**Request for Additional Information No. 413(4772), Revision 1,
Questions 07.08-32, 07.08-35, and 07.08-38**

U.S. EPR Standard Design Certification

Docket No. 52-020

SRP Section: 07.08 - Diverse Instrumentation and Control Systems

Figure 07.08-32-1—D3 SGTR Event – Break Flow

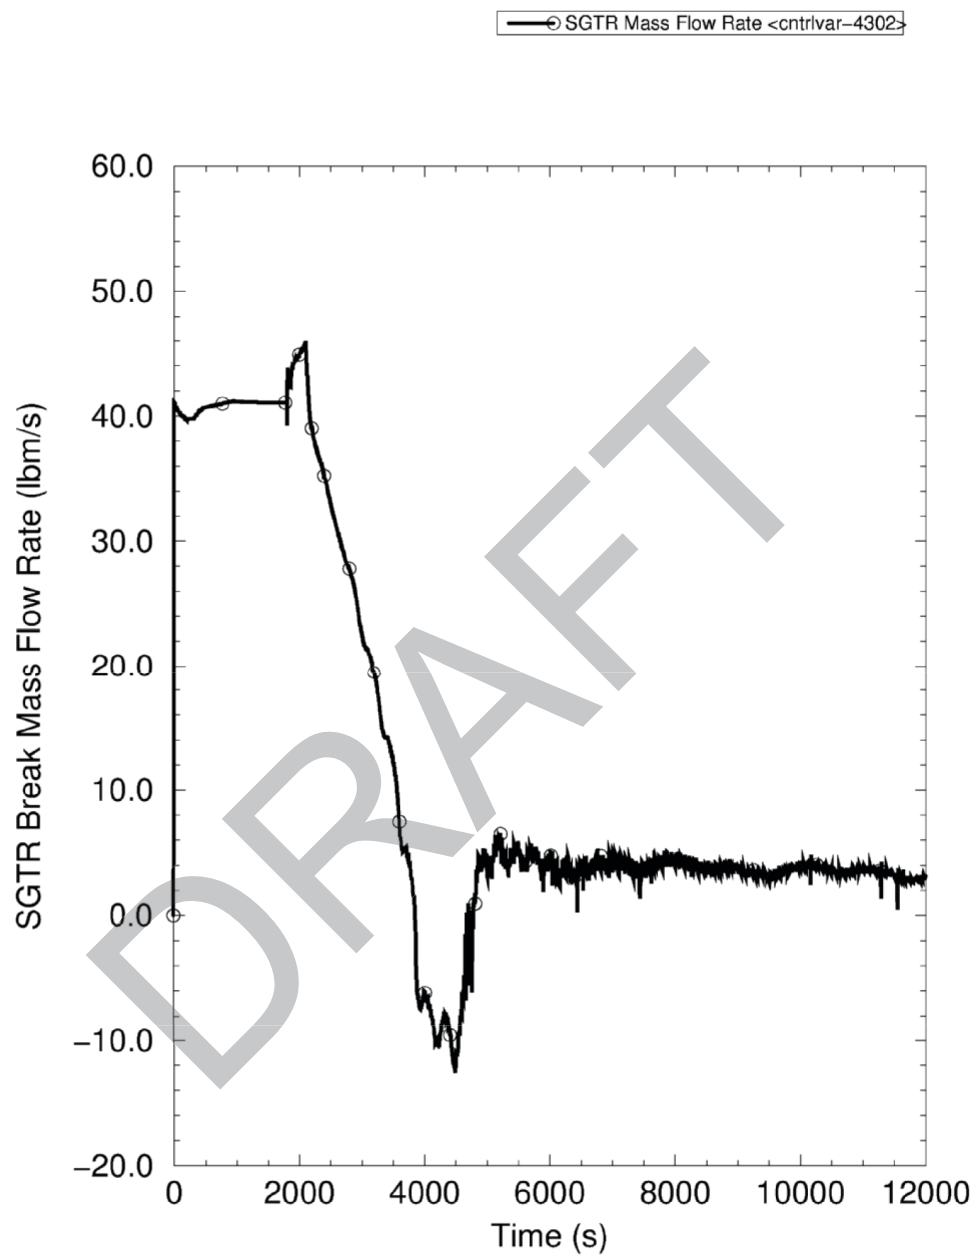
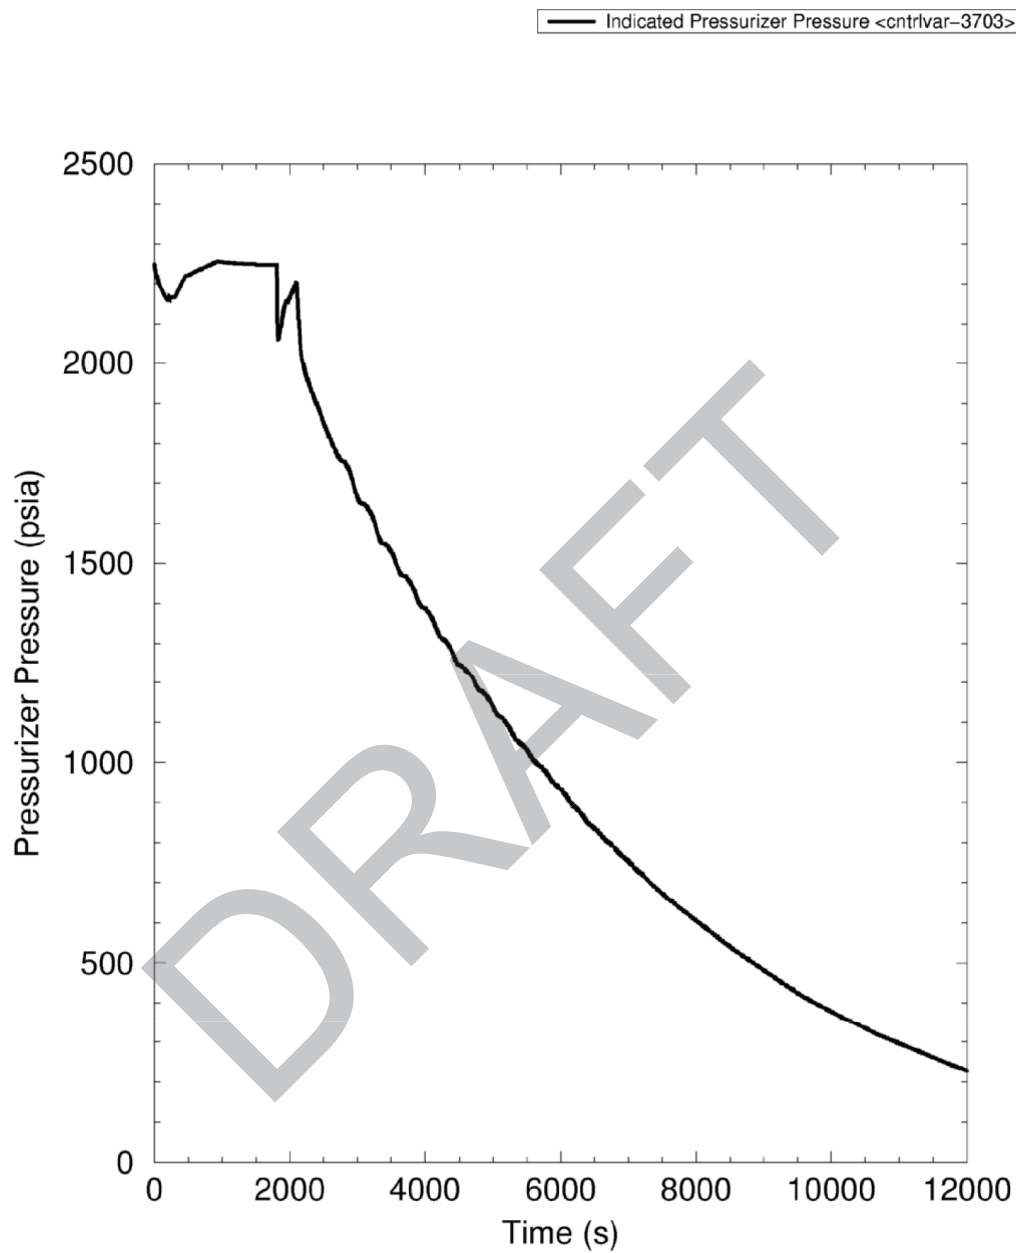
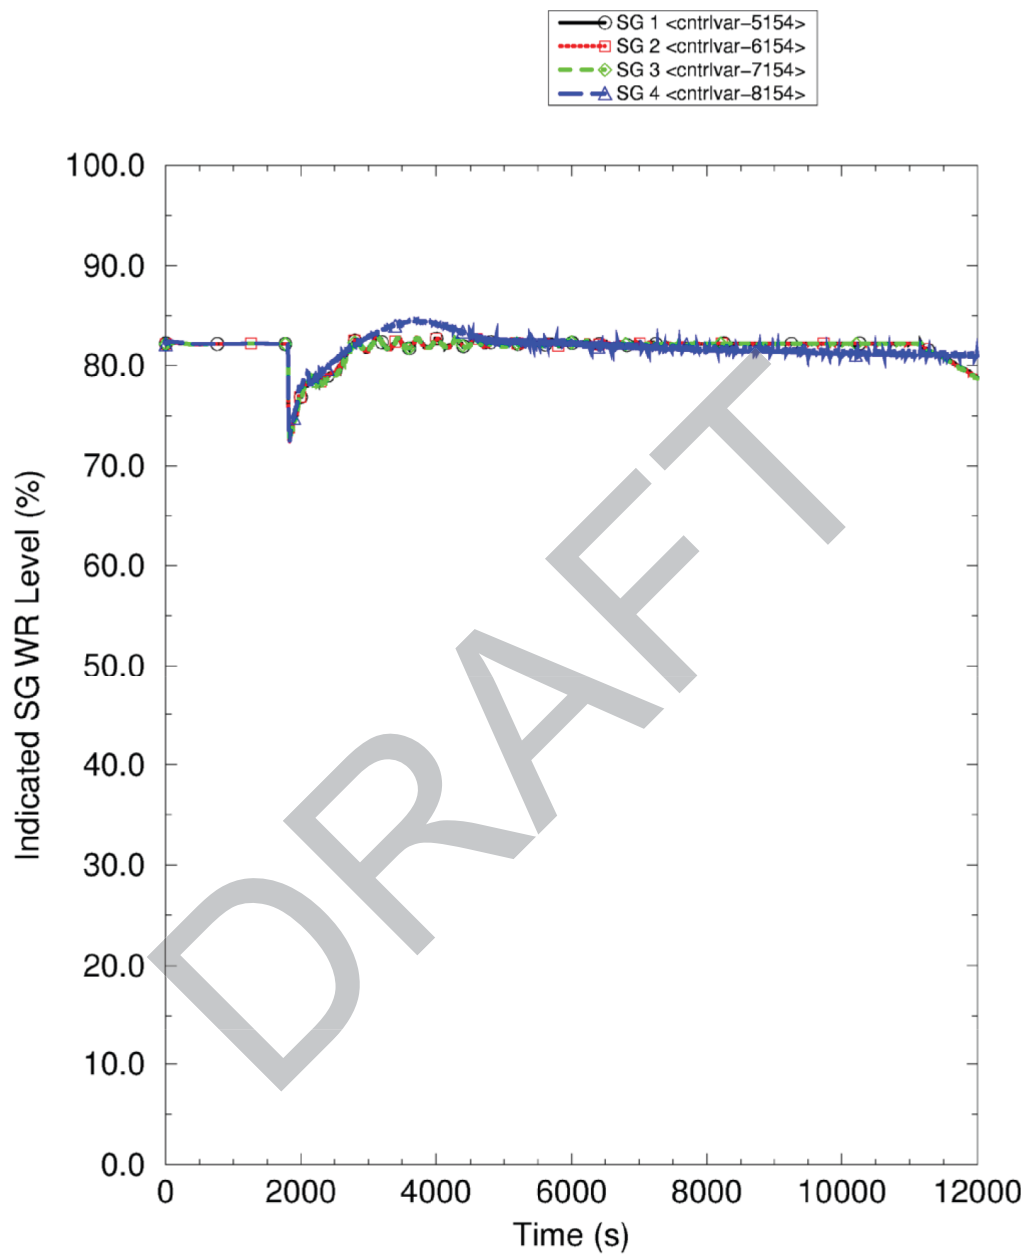
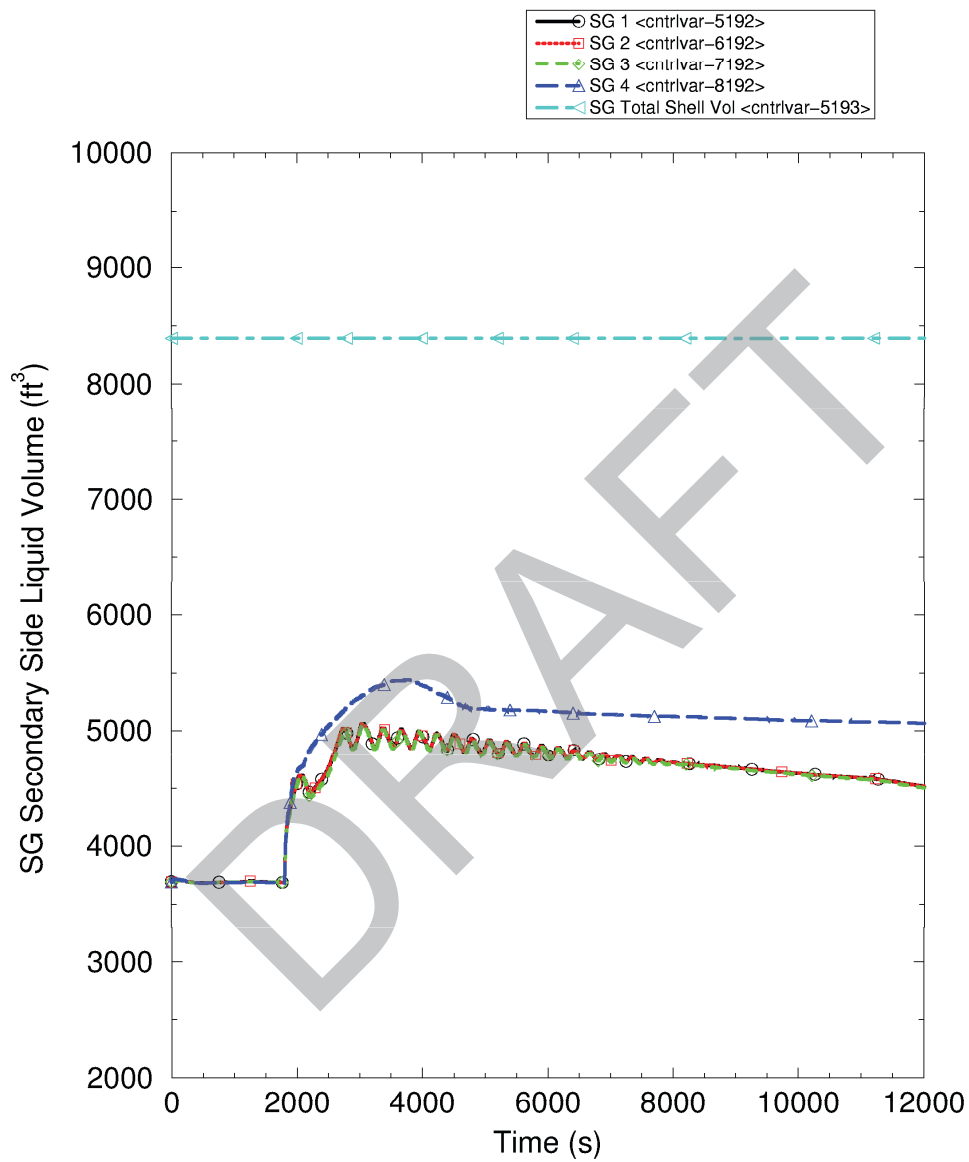
For the Steam Generator Tube Rupture (SGTR) event described in ANP-10304 Rev 1 Section A.3.7.2, provide the following additional information:

- a. An explanation of why the D3 analysis of the SGTR results in SG overfill as compared to the FSAR Section 15.6.3 analysis which does not show SG overfill,
- b. The design reference basis for main steam line loading with solid fill at a hydrostatic pressure of 1.25 design pressure, and
- c. An assessment of the possibility of steam line water hammer occurrence during the SG overfill portion of the SGTR event.

Section A.3.7.2 of ANP-10304 Rev 1 reports that the Steam Generator Tube Rupture (SGTR) event results in an overfill of the affected steam generator and discharge of liquid into the main steam line, whereas the SG does not overfill in FSAR Section Chapter 15 SGTR analysis. With essentially the same manual controls available and credited for the FSAR analysis and D3 analysis, plus availability of the DAS MFW isolation on SG High Level, it is unclear why the SGTR with PS SWCCF results in SG overfill. The staff is not able to identify design descriptions that would permit sufficient understanding in order to complete the safety evaluation.

The original evaluation of the diversity and defense-in-depth (D3) steam generator tube rupture (SGTR) event was made by estimating the steam generator (SG) level response. No operator action was credited for isolation of the main feedwater (MFW) valves in this evaluation. Instead, the rate of SG level increase from the U.S. EPR FSAR Tier 2 analysis was extended for the amount of time that it would take the SG level control system to respond. This estimation resulted in a level of 90 percent wide range when the valves reached full closure. A D3-specific analysis was performed with S-RELAP5 to more precisely evaluate the SG overfill behavior in a best estimate SGTR event. The best estimate SGTR analysis credits the following automatic control systems:

load control valves works as designed and the low load control valve (LLCV) (<5-20 percent reactor power) or very low load control valve (VLLCV) (<5 percent reactor power) operate to maintain SG level at the programmed setpoint. After the affected SG is isolated, no further FW is introduced to that SG.

In the D3 SGTR analysis, the operation of the chemical and volume control system (CVCS) system compensates for the break flow (see Figure 07.08-32-1). The pressurizer pressure (see Figure 07.08-32-2) remains above the setpoint, and an automatic RT does not occur prior to 30 minutes. At 30 minutes, the operator performs a manual RT. After RT, the operator performs the actions necessary to isolate the affected SG. In an isolated SG, MFW, emergency feedwater (EFW), and SG blowdown are isolated, the main steam relief train (MSRT) setpoint is raised above the safety injection (SI) shutoff head, and the main steam isolation valve (MSIV) is closed. The operator then manually initiates a cooldown with the unaffected SGs and performs a concurrent RCS depressurization to allow the RCS to be connected to the residual heat removal system (RHRS). The maximum level, 84 percent wide range (58 percent narrow range), is reached at 63 minutes (see Figure 07.08-32-3 and Figure 07.08-32-4). Because the SG does not overfill throughout the event, an evaluation of main steam line loading and main steam line water hammer is not necessary.

Figure 07.08-35-1—Pressurizer Level Setpoints

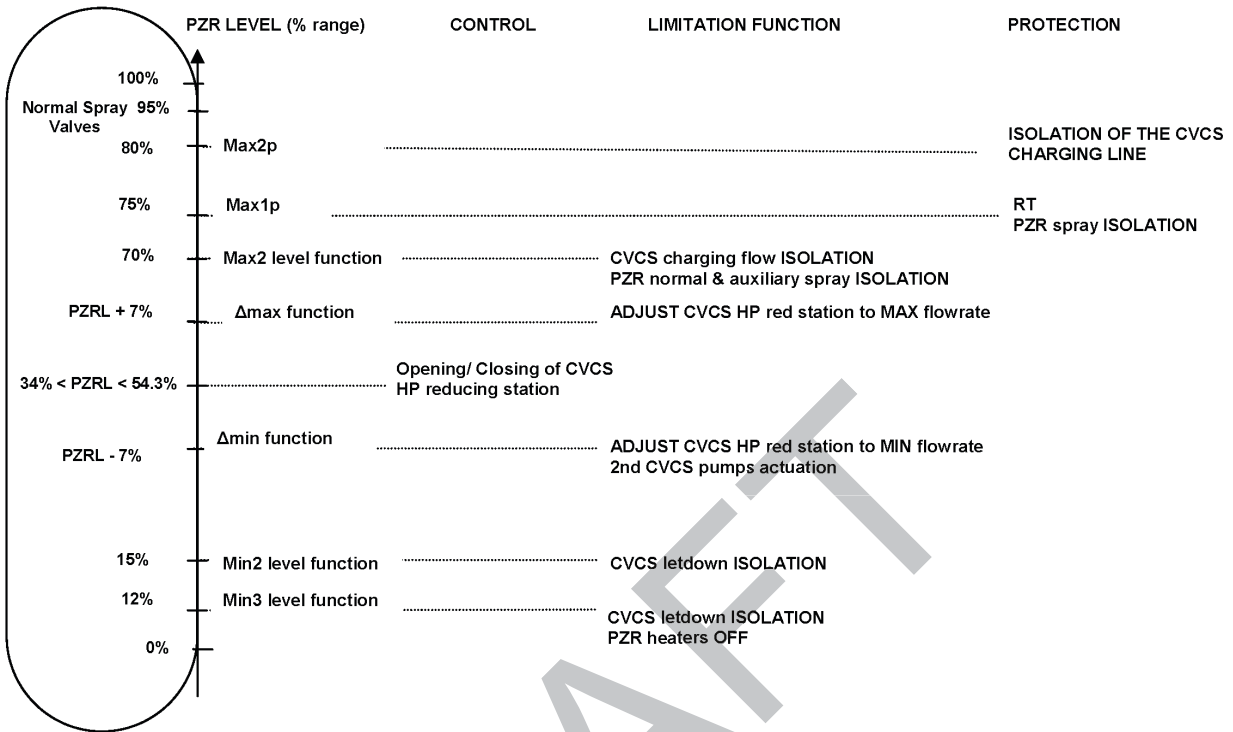
Identify the credited diverse means to address the loss of the PS initiated safety functions of RT on a high pressurizer level and CVCS isolation on high pressurizer level, as discussed in ANP-10304, Revision 1, Section A.3.6.2, "CVCS Malfunction that Increases RCS Inventory," in accordance with the D3 policy stated in SRM to SECY-93-087, Point 3. If the credited diverse means are manual actuations, provide the detailed design descriptions that would address the guidance of Standard Review Plan (SRP) Appendix 18-A, "Crediting Manual Operator Actions in Diversity and Defense-In-Depth (D3) Analyses." Applying the credited diverse means, provide the following additional information:

- a. A description of the operator action sequence, starting with recognition of the increasing RCS inventory event and ending with isolation of CVCS,
- b. The time within which the operator can accomplish the required actions to isolate CVCS and terminate the event, and
- c. Identification of the procedure or procedure type (e.g., EPGs) that will prescribe the steps to accomplish the required operator action and whether a special D3 coping procedure is required.

For the Increase in RCS Inventory event with SWCCF, as described in Section A.3.6.2 of ANP-10304 Rev 1, the transient does not terminate on Pressurizer High Level as is the case with the FSAR Chapter 15 analysis. In the FSAR analysis, the pressurizer high level causes a reactor trip and CVCS isolation. For the D3 analysis, neither the reactor trip nor the CVCS isolation occurs, and the pressurizer fills solid. Although Section A.3.6.2 of ANP-10304 Rev 1 states that pressurizer PSRVs are capable of relieving water, thus ensuring that the RCS pressure boundary is maintained, sufficient indication and procedures should be available to ensure that the plant operations personnel recognize and terminate the event in a timely manner. The staff is not able to identify design descriptions that would permit sufficient understanding in order to complete the safety evaluation.

protection system (PS). For the diversity and defense-in-depth (D3) analysis, with a software common cause failure (SWCCF) in the PS, the RT and the CVCS isolation does not occur. Technical Report ANP-10304, Revision 1, Section A.3.6.2 conservatively estimates that it takes 24 minutes for the pressurizer to fill solid if the CVCS malfunction continues unabated. Twenty-four minutes is sufficient time for the operator to recognize and terminate the charging flow before the pressurizer overfills. Under this scenario, there are indications/opportunities that alert the operator that the pressurizer is filling uncontrollably. The operator sees a deviation alarm when the pressurizer level exceeds the normal pressurizer level control band. The VCT tank level decreases, resulting in the automatic start of the boron and reactor water makeup pumps.

This assessment is conservative because systems that would be available for event mitigation are not credited. In the U.S. EPR design, a pressurizer level limitation function exists in the process automation system (PAS), which is separate from the PS. This function improves plant availability by avoiding a RT and other safety-related function actuations for events that lead to increasing levels in the pressurizer. Figure 07.08-35-1 shows that the limitation function isolates charging and pressurizer spray when the pressurizer level reaches 70 percent. The pressurizer level limitation function will terminate this event before filling the pressurizer. This automatic feature will actuate approximately 8.5 minutes after event initiation.

With credit for the pressurizer level limitation system, there is no need for operator action for this event. Charging flow would be automatically isolated when pressurizer level reaches 70 percent. Specific procedures are not required for this event.

Figure 07.08-38-1—D3 - Increase in Steam Flow - Case Stabilizing under the High Neutron Flux Setpoint - Power

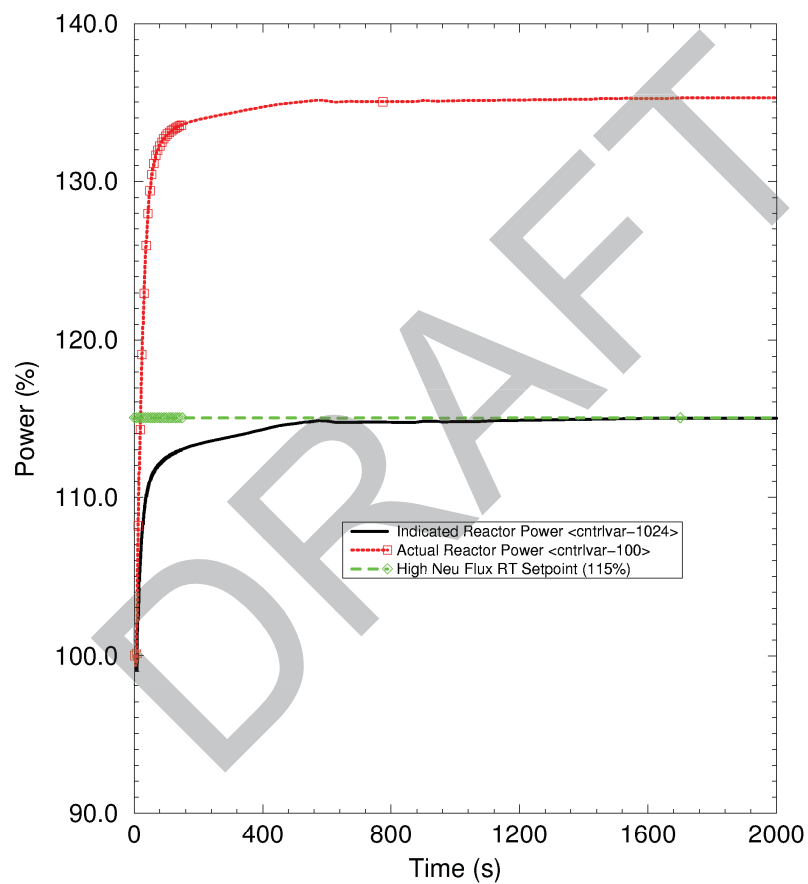
For Section A.3.2.3 of ANP-10304 Rev 1, describe the neutronics calculations that are done to determine the decalibration. In particular, address the issue of the temperature decrease in neutron reflector coolant. Also describe how the decalibration is implemented in the S-RELAP5 model.

Section A.3.2.3 of ANP-10304 Rev 1 states that the reduction in downcomer water temperature that results from the Increase in Steam Flow event causes the excore neutron detectors to become decalibrated, thereby delaying reactor trip. The staff is not able to identify design descriptions that would permit sufficient understanding in order to complete the safety evaluation.

The temperature decalibration factors are determined by an independent adjoint DORT (Discrete Ordinates Transport) calculation. This adjoint calculation uses the Oak Ridge National Laboratory (ORNL) programs GIP and DORT. The GIP program generates 47 group neutron cross sections for the materials internal and adjacent to the U.S. EPR pressure vessel. The DORT program calculates the adjoint fluxes necessary to obtain the desired excore detector response factors for a 25°F temperature variation around the nominal inlet coolant temperature. Because of the uncertainty on the exact location of the excore detector, the factor is calculated for three different locations of the excore detector. The temperature decalibration factor, DF, for the locations is calculated to be 0.51 percent/°F.

Formula (1) is incorrect. The correct formula for utilization in the best estimate D3 analyses is:

$$revisedIndicatedPower(\%) = reactorPower(\%) \times \left\{ 1 + \frac{\left[\Delta T(^{\circ}F) \times DF\left(\frac{\%}{^{\circ}F}\right) \right]}{100(\%)} \right\}$$

According to the numerical simulation in this response, the revised indicated power would be lower because of the negative ΔT , and the conditions would be farther from the RT conditions. The transient analysis would not be impacted by this correction. However, between the end of cycle (EOC) and the beginning of cycle (BOC), reactivity kinetics conditions can lead to the stabilization of the indicated neutron flux signal just under the RT setpoint. A transient calculation was performed with these conditions for the moderator temperature coefficient (MTC) and fuel Doppler coefficient (DTC). Figure 07.08-38-1 shows the indicated power and the nuclear power. For this case, Figure 07.08-38-2 shows the corresponding departure from nucleate boiling ratio (DNBR) and the linear power density (LPD) margin.

The calculation with the approximate final conditions of the increased steam flow event (Reactor power = 131 percent and $\Delta T = -34.5^{\circ}F$), shown in Technical Report ANP-10304, Figures A.3.2-1 and A.3.2-2, gives 113.41 percent for the current indicated power and 107.95 percent for the revised indicated power (the RT setpoint is 115 percent).
